Chic Wings (BD) Intimates Co. Ltd.

3 March 2025

2. Observations

Observation-1: Substructure retrofitting works need to be verified & assessed (Production Building)

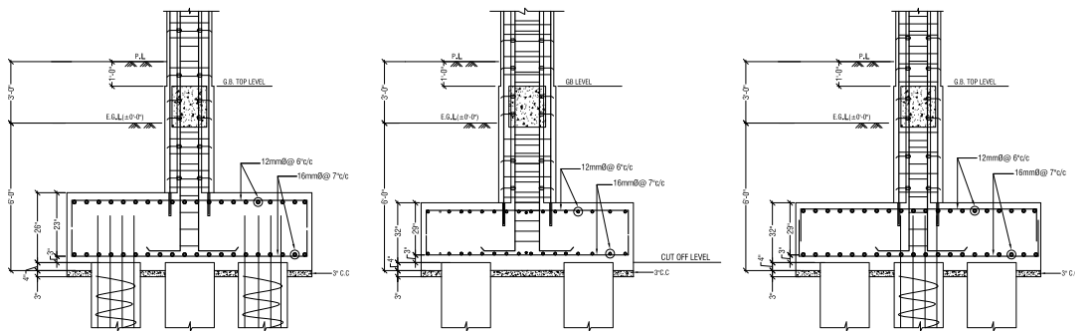
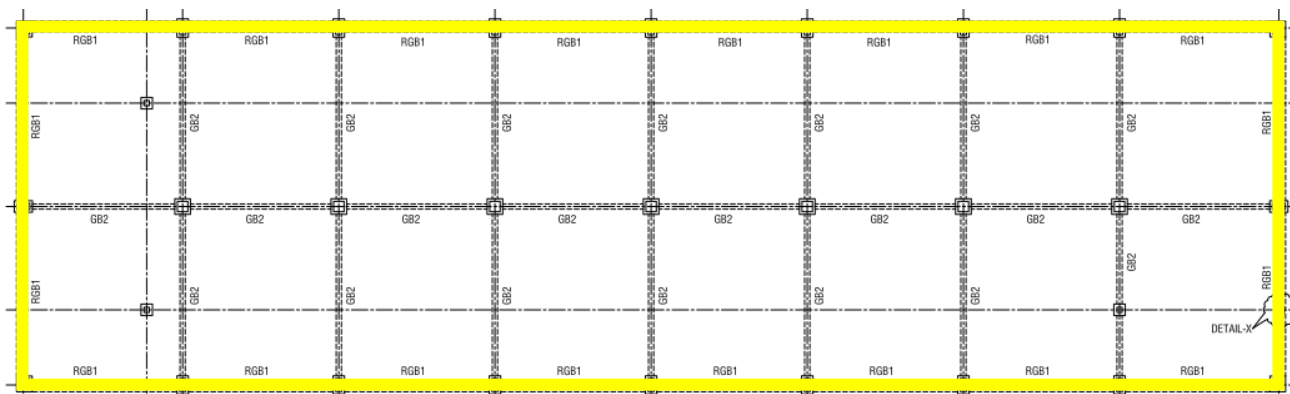
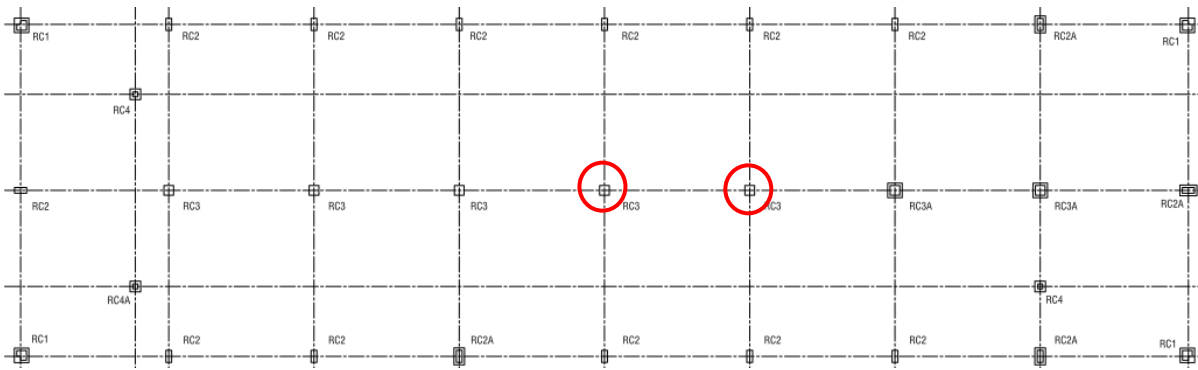
Description: The as-built drawings indicate pile cap thicknesses of 750mm, 900mm, and 900mm, whereas the construction drawings specify 400mm, 550mm, and 475mm, respectively. Additionally, the pile caps and peripheral grade beams (highlighted in yellow in the figure) are labeled as retrofitted in the as-built drawings. However, the factory could not provide any pictorial evidence, QC certification, or sufficient test reports for the retrofitting works, apart from four sets of cylinder test reports (two for columns and two for grade beam retrofitting). Furthermore, the EA report assumes a rebar yield strength of 72.5 ksi for the retrofitting work, but no supporting test report was available.

4th floor column layout

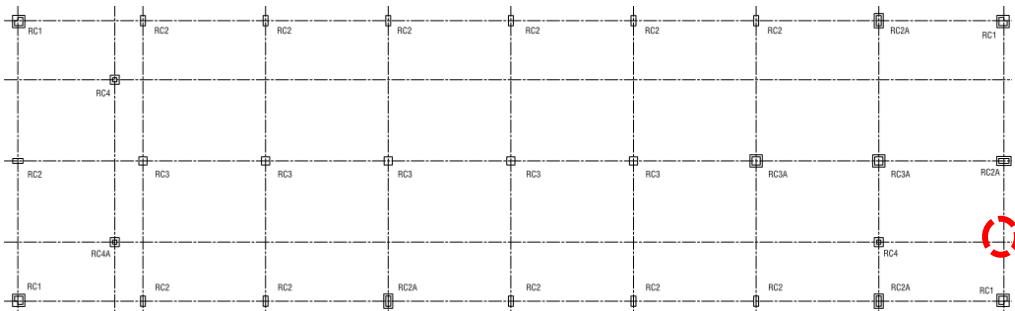
Description: According to the available core test report, six cores were extracted from ground-floor columns. However, two additional core extraction marks, highlighted in red on the column layout, were observed on the 4th floor.

Column Layout

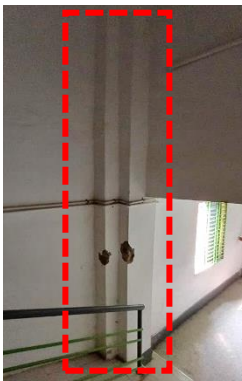
Description: An undocumented ground-floor column has been found, and its connection to the main framing system needs to be verified.

Roof Shed above 5th floor dining

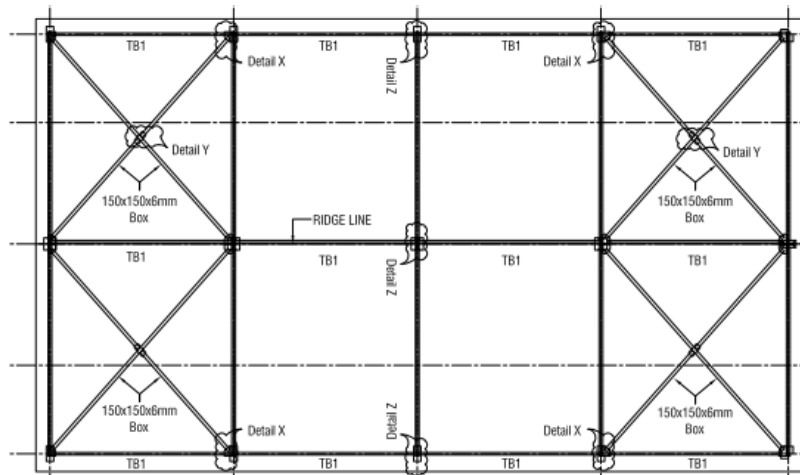
Description: Portal frame was observed in the short direction. Compression strut or load transfer media was not observed in the long direction.
